Work Order ID 129682

Item Name: Quick Release Basket Mounting Spacepod™ & Squirrel Cheek Fits LH or RH

TO AMEND INSTALLATION INSTRUCTIONS D350-607-3 Rev.D,
INSTALLATION INSTRUCTIONS D350-607-4 Rev. C AND
INSTRUCTIONS FOR CONTINUED AIRWORTHINESS ICA-D350-607 REV. 6
REF TCCA STC: SH94-14
REF FAA STC: SR00213NY
REF EASA STC: EASA.10016996
REF BRAZILIAN STC: 2007S03-03/-04/-05/-06

A	NEW ISSUE	AJS	14.05.16
REV.	DESCRIPTION	BY	DATE
DESIGN	AJS	DART AEROSPACE LTD HAWKESBURY, ONTARIO, CANADA	
DRAWN	AJS		
CHECKED		DRAWING NO.	REV. A
MFG. APPR.	N/A	DSI 9699	SHEET 1 OF 2
APPROVED		TITLE	SCALE
DE APPR.		LUG REPLACEMENT	NTS
DATE	14.05.16	COPYRIGHT © 2014 BY DART AEROSPACE LTD THIS DOCUMENT IS PRIVATE AND CONFIDENTIAL AND IS SUPPLIED ON THE EXPRESS CONDITION THAT IT IS NOT TO BE USED FOR ANY PURPOSE OR COPIED OR COMMUNICATED TO ANY OTHER PERSON WITHOUT WRITTEN PERMISSION FROM DART AEROSPACE LTD.

FIGURE 1: INSTALLATION OF D4775-041 FWD STRUT

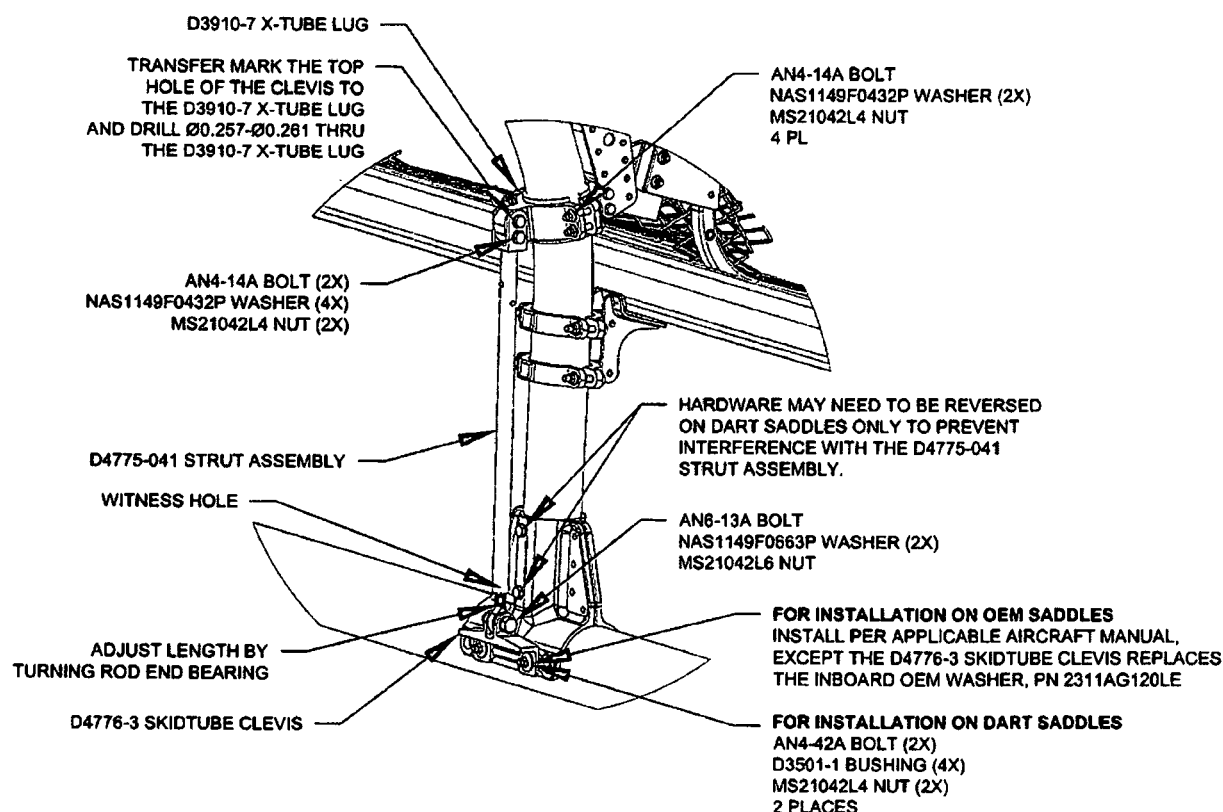
- 3.1 Substitute the Forward Lower D3910-5 X-Tube Lug with the D3910-7 X-Tube Lug as shown in Figure 1.
- 3.2 Install the forward D4775-041 Strut Assembly. Transfer mark from the upper hole on the clevis of the D4775-041 Strut Assembly to the D3910-7 X-tube Lug and drill thru the lug $\varnothing 0.257$ - $\varnothing 0.261$ as shown in Figure 1. Touch up chemical conversion coating per MIL-DTL-5541. Check the witness holes located at the bottom end of the D4775-041 Strut Assemblies to ensure that the thread from the rod end extends past the witness hole.
Torque MS21042L4/-4 nuts to 50-70 in-lbs (5.7-7.9 N-m). Torque MS21042L6/-6 nuts to 160-190 in-lbs (18.1-21.5 N-m).
- 3.3 Complete the installation in accordance with Installation Instructions D350-607-3 Rev. D or D350-607-4 Rev. C.

Modify the quantities for D3910-5 and add D3910-7 as follows:
